Low Density Residential Zone

Clause 12.4.1(A5)

Figure 2 – Source Listmap – Threatened Native Vegetation Communities

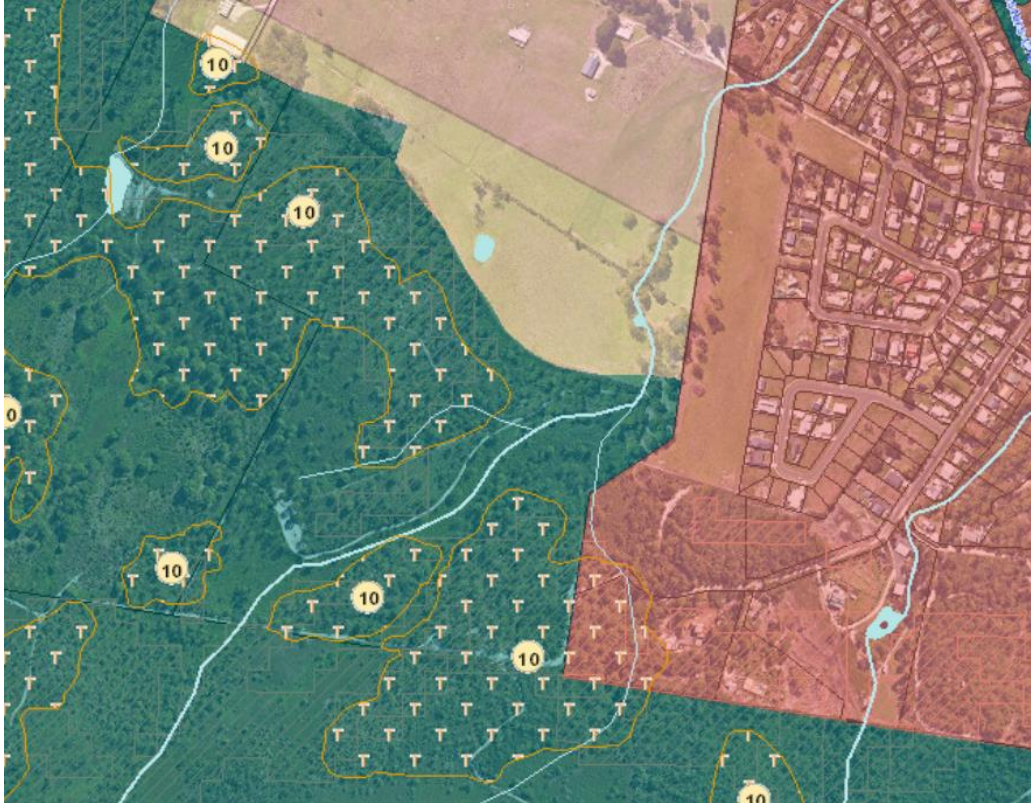
P1(c)(i) states that the proposal be on a site that – “has been assessed to have no potential or benefit for protection and conservation or hazard management.” As shown on figure 2 below, the lot contains the overlay for Threatened Native Vegetation Communities. No ecological reporting has been provided for the site. It is also shown of figure 3 that the site is also a Wedge Tailed Eagle nesting area. No consideration has been provided.
